Issue	Date	Event
A	04.08.22	Issue for Section 4.55

Project
 28 Lockwood Avenue, Belrose

Drawing Title :
 Basement 04 plan

Basement 03 plan

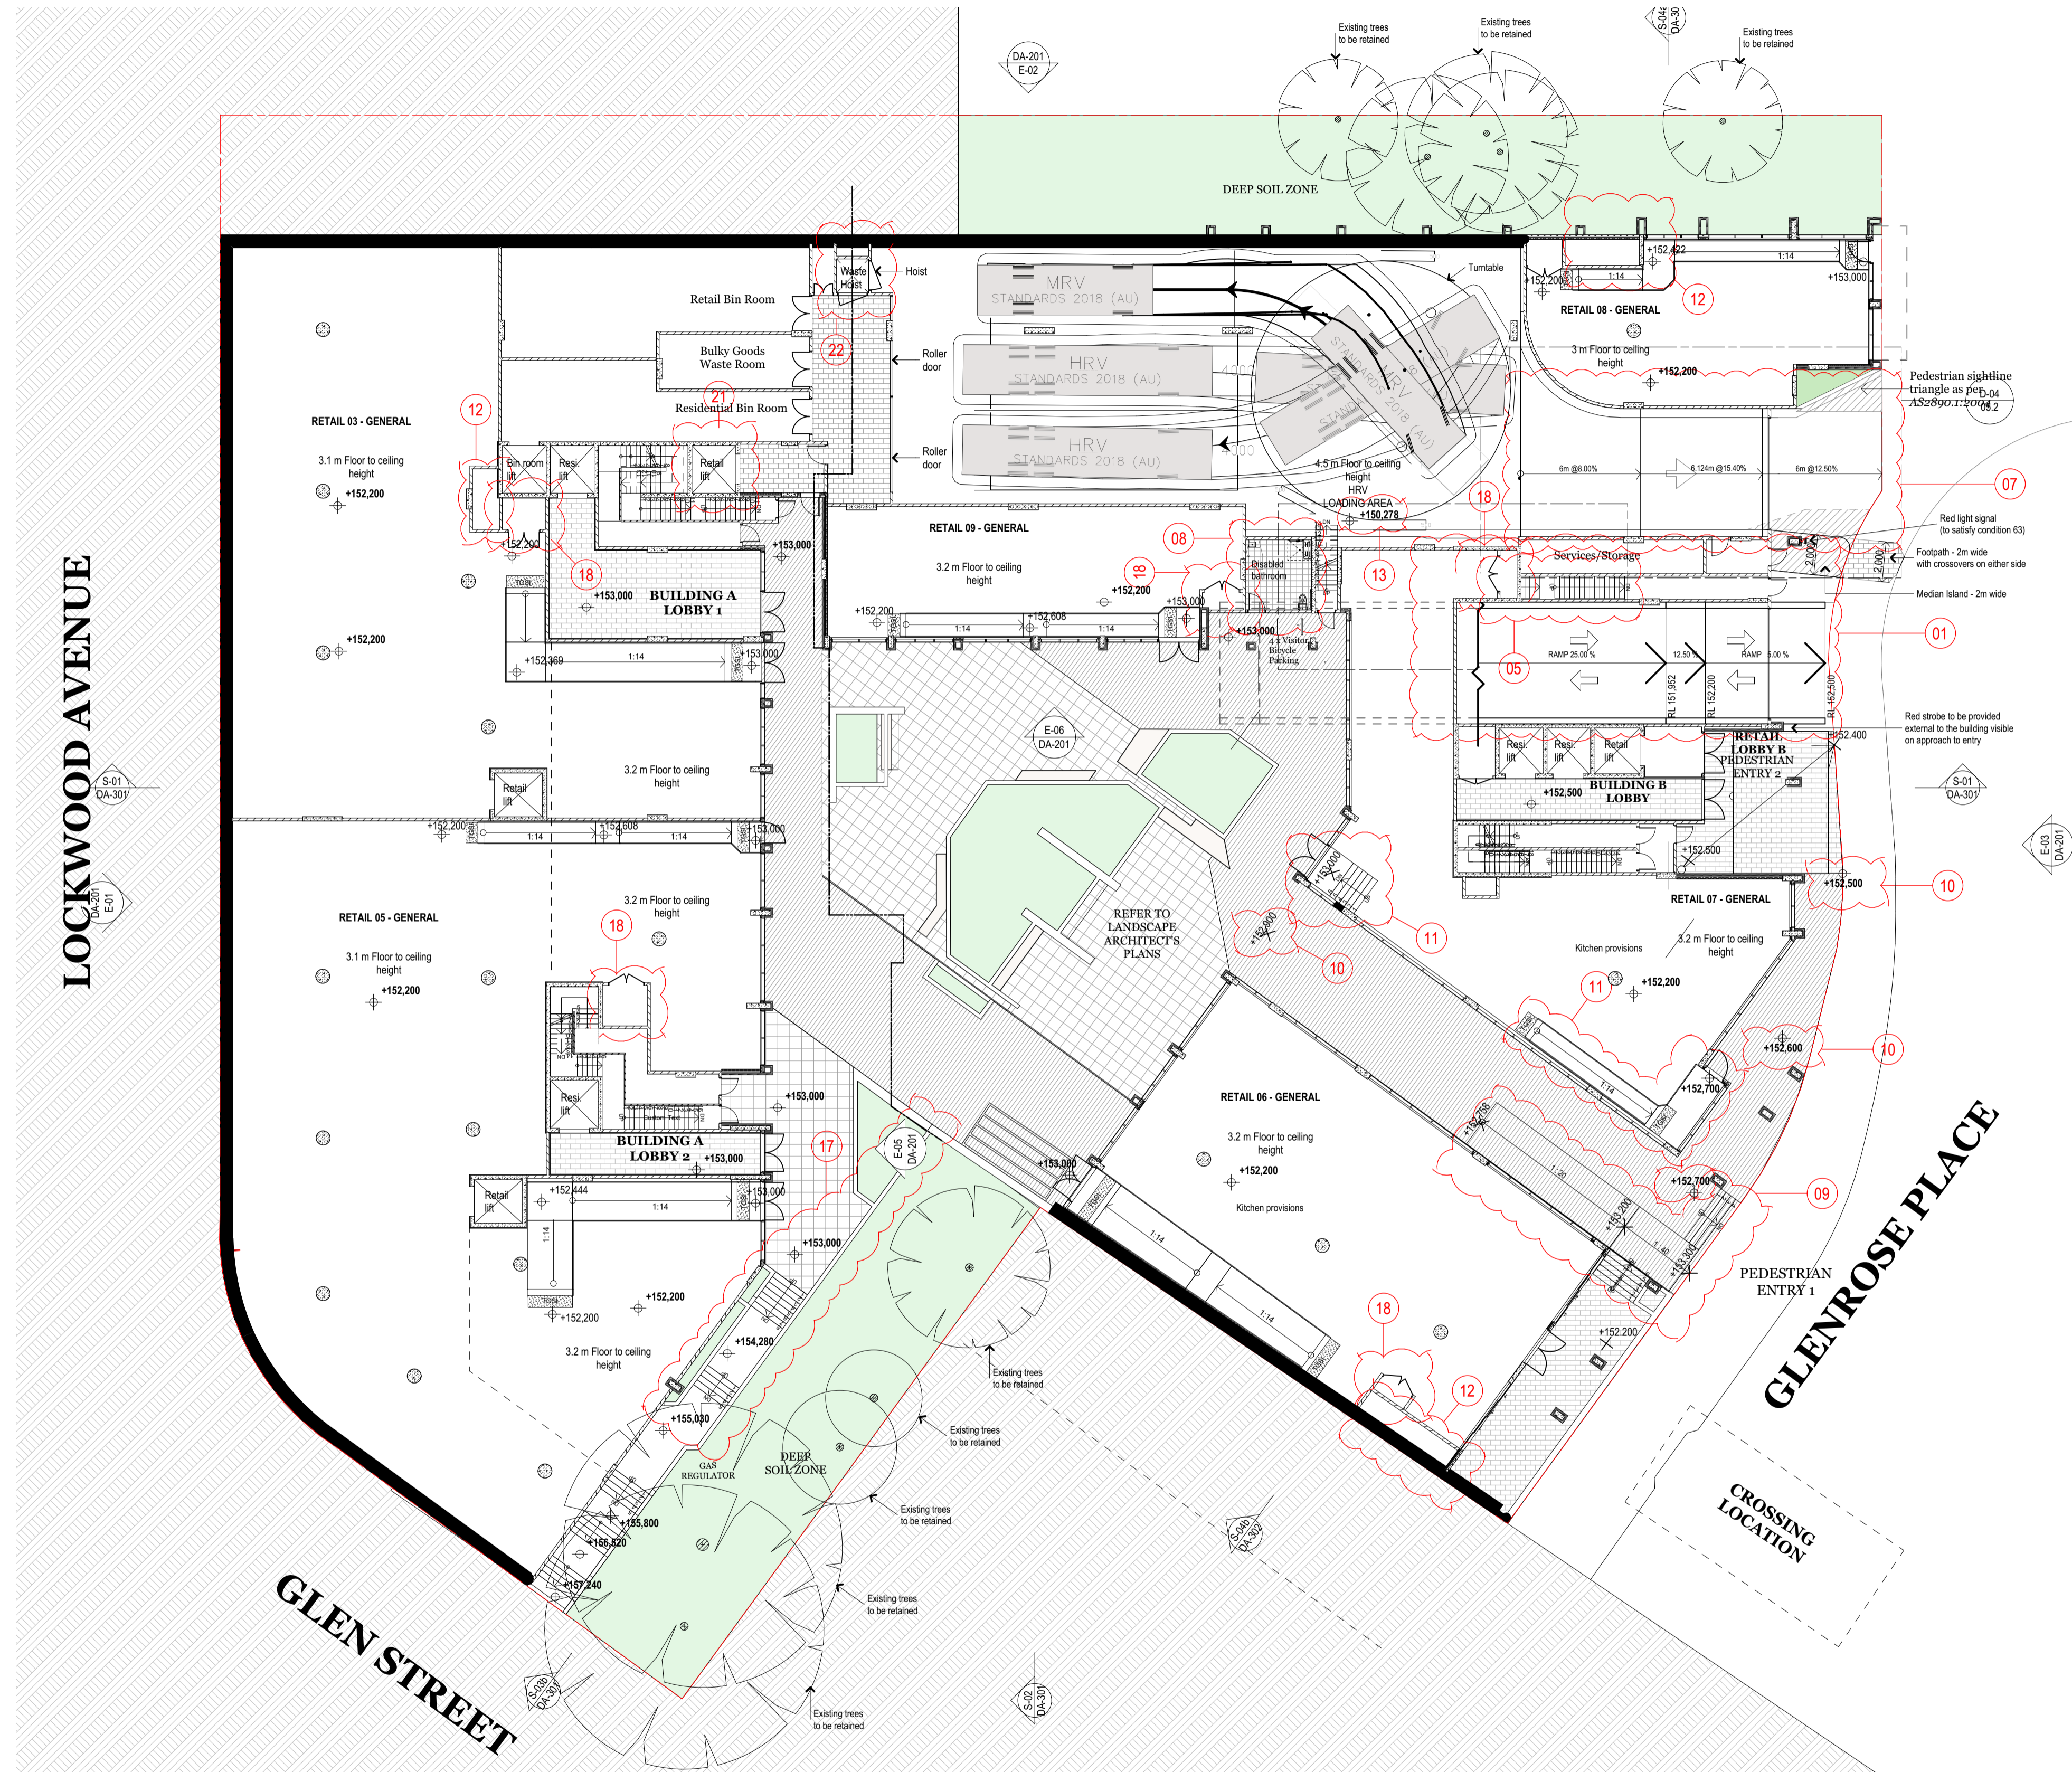
- 1- Entry and exit ramp combined and relocated.
- 2- Traffic flow, car spaces and storage cages rearranged.
- 3- Floor RL lowered.
- 4- EOT and accessible bathroom relocated.

- 5- Fire stairs relocated to comply with NCC.
- 6- Plant and utility rooms rearranged.
- 7- Loading dock entry/exit ramp modified.
- 8- Accessible bathroom provided

- 9- Glenrose pedestrian entry ramp and steps modified.
- 10- levels modified.
- 11- Entry to shop number 07 modified.
- 12- Mechanical exhaust shafts located.

- 13- Loading dock RL modified.
- 14- Face brick removed from intermediate exposed slab edges.
- 15- Proposed clubhouse/communal room.
- 16- Fire stairs relocated and minor internal unit rearranged adjacent to the new stair location.

- 17- Glen street pedestrian entry modified for structural rationalisation.
- 18- Electrical switch boards located.
- 19- External wall modified.
- 20- Unit 1.01: East wall relocated, balcony deleted.

- 21- Waste lift is changed to Retail lift and it drops to basement 04.
- 22- The hoist lift in the loading dock is changed to waste lift and it drops to basement 03.

- 23- Roof extended over enclosed balcony.
- 24- Internal layouts modified for more efficient, spatial use and relationship:
 LG01, LG02, LG06, LG10, LG12, LG14, LG15, LG18.
 G01, G02, G05, G09, G13, G15, G16.
 L1.02, L1.05, L1.08, L1.12, L1.13, L1.14
 The amendments for the following units are subject to section 4.55 application:
 LG03, LG05, LG07, LG08, LG09, LG11, LG13, LG17, G03, G06, G08, G10, G11, G12, G14, L1.01, L1.03, L1.04, L1.09, L1.11.

- 25- New aluminum windows and doors.

Drawing Title :
 Level 01 plan

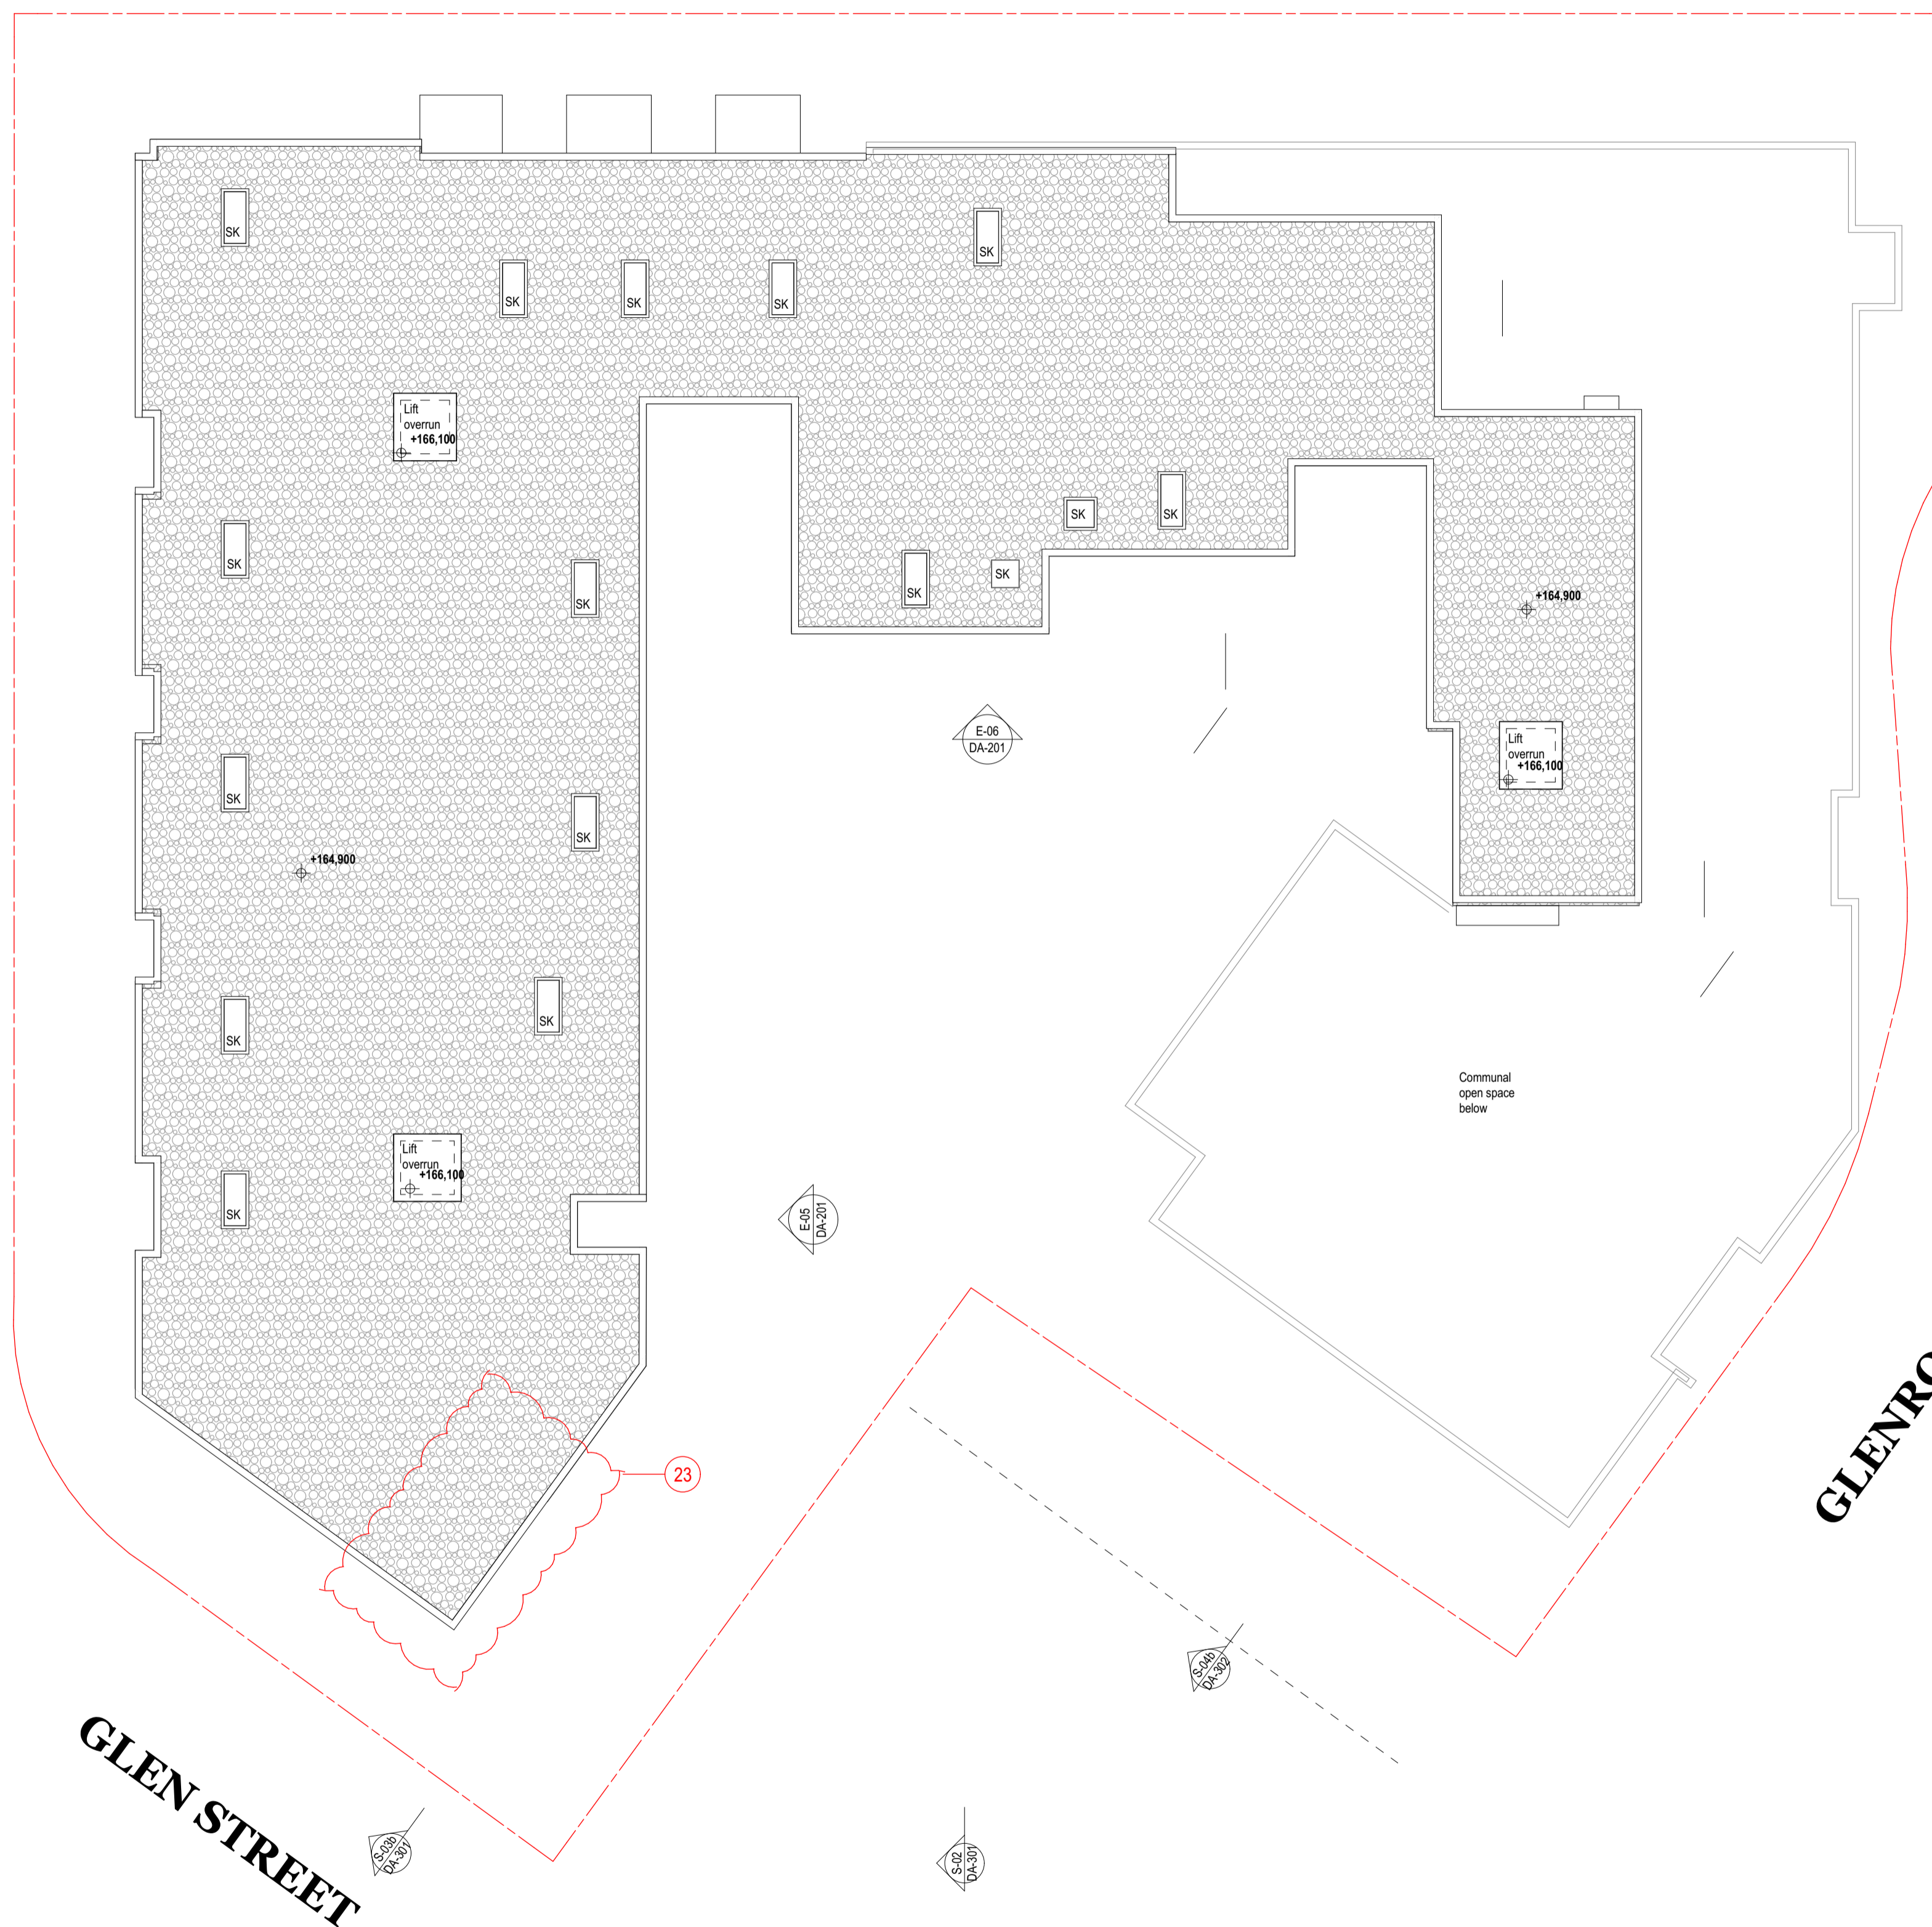
- 1- Entry and exit ramp combined and relocated.
- 2- Traffic flow, car spaces and storage cages rearranged.
- 3- Floor RL lowered.
- 4- EOT and accessible bathroom relocated.

- 5- Fire stairs relocated to comply with NCC.
- 6- Plant and utility rooms rearranged.
- 7- Loading dock entry/exit ramp modified.
- 8- Accessible bathroom provided

- 9- Glenrose pedestrian entry ramp and steps modified.
- 10- levels modified.
- 11- Entry to shop number 07 modified.
- 12- Mechanical exhaust shafts located.

- 13- Loading dock RL modified.
- 14- Face brick removed from intermediate exposed slab edges.
- 15- Proposed clubhouse/communal room.
- 16- Fire stairs relocated and minor internal unit rearranged adjacent to the new stair location.

- 17- Glen street pedestrian entry modified for structural rationalisation.
- 18- Electrical switch boards located.
- 19- External wall modified.
- 20- Unit 1.01: East wall relocated, balcony deleted.

- 21- Waste lift is changed to Retail lift and it drops to basement 04.
- 22- The hoist lift in the loading dock is changed to waste lift and it drops to basement 03.

- 23- Roof extended over enclosed balcony.
- 24- Internal layouts modified for more efficient, spatial use and relationship:
 LG01, LG02, LG06, LG10, LG12, LG14, LG15, LG18.
 G01, G02, G05, G09, G13, G15, G16.
 L1.02, L1.05, L1.08, L1.12, L1.13, L1.14
 The amendments for the following units are subject to section 4.55 application:
 LG03, LG05, LG07, LG08, LG09, LG11, LG13, LG17, G03, G06, G08, G10, G11, G12, G14, L1.01, L1.03, L1.04, L1.09, L1.11.

- 25- New aluminum windows and doors.
